# CITY OF ALBUQUERQUE

RE: **7901 Las Lomas NE**  
**Revised Grading Plan Stamp Date: 2/10/20**  
**Drainage File: D16D002I**

Based on the submittal received on 2/12/20, the revised grading plan cannot be approved until the following are corrected:

7901 LAS LOMITAS	DRAWN BY WCWJ
	GRADING AND DRAINAGE PLAN	DATE 12-17-19
2/10/20		2109049-LAYOUT-6-05-19
DAVID SOULE P.E. #14522		SHEET #
	1606 CENTRAL AVENUE SE SUITE 201 ALBUQUERQUE, NM 87106 (505) 872-0999	JOB # 2109049

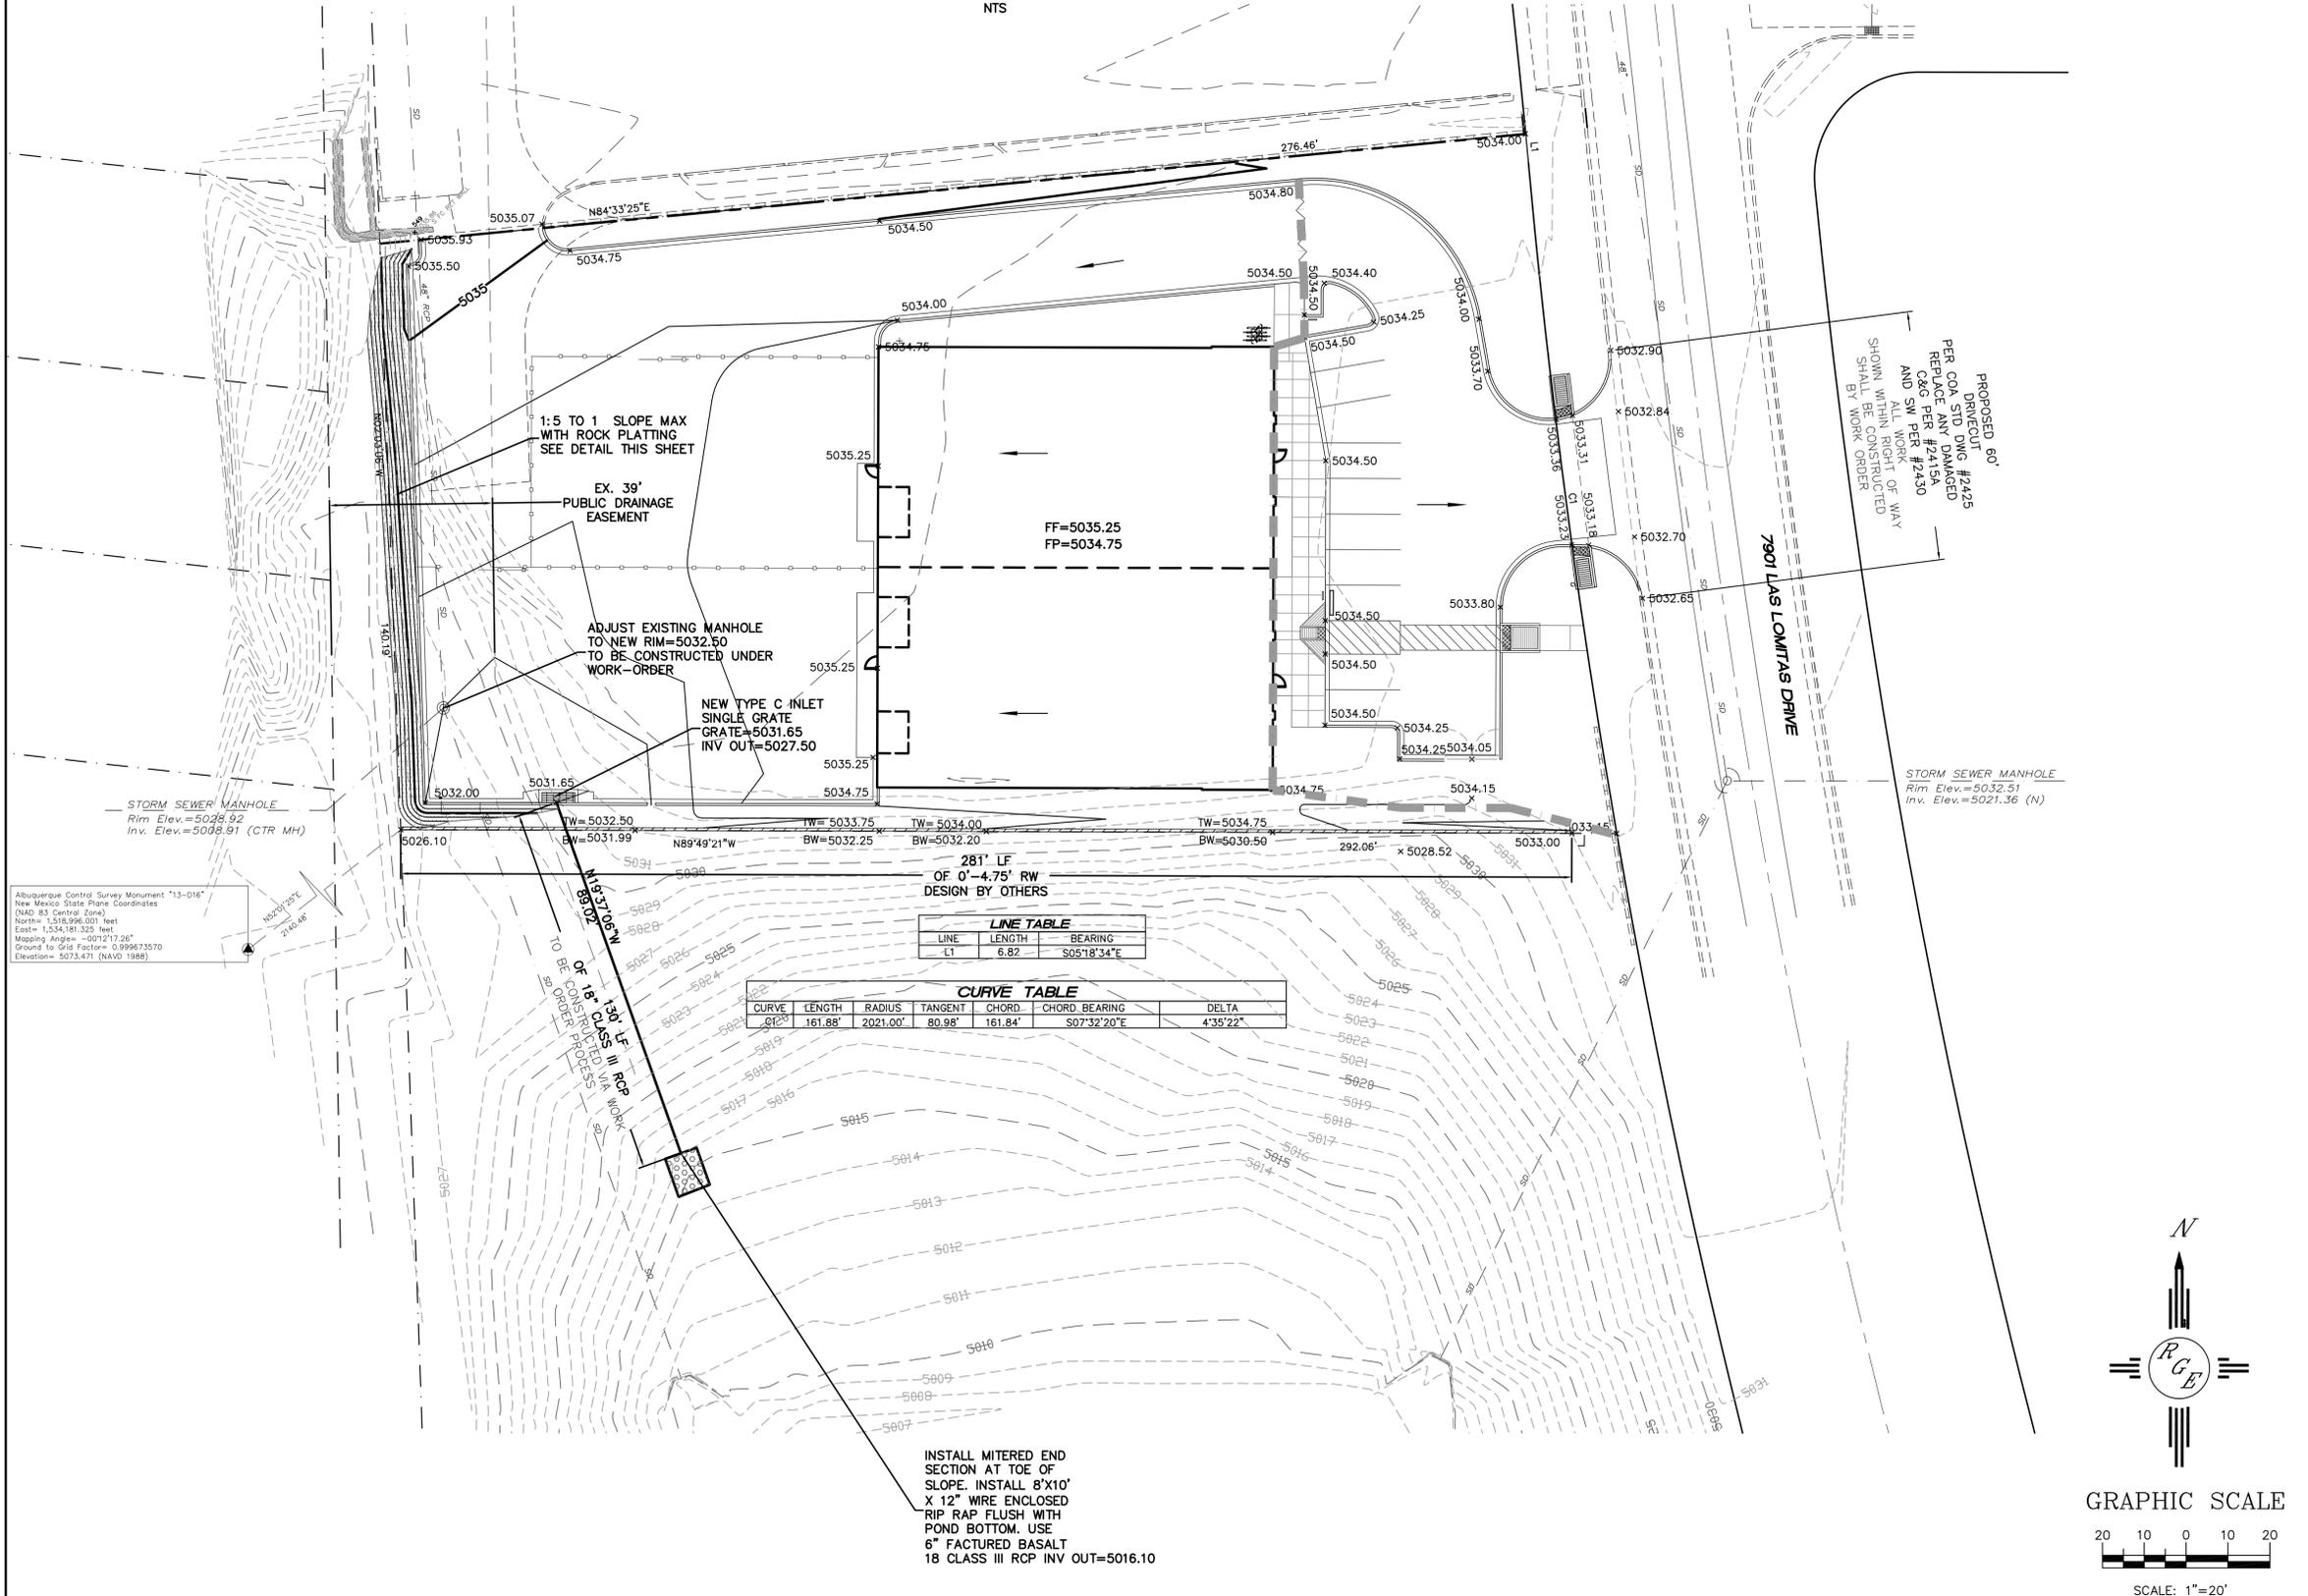
1. Extend the storm drain to outfall at the bottom of the pond. Alternatively, you could provide a concrete swale to convey the drainage from the pipe outlet to the bottom of the pond (will require channel capacity calculations). For either option the rip-rap pad will be needed at the pond bottom.

2. Provide a section through the proposed retaining wall; ensure it is wholly contained on the private property. How will the existing fence be affected by this wall? Will it need to be rebuilt on top of, or adjacent to, the retaining wall?
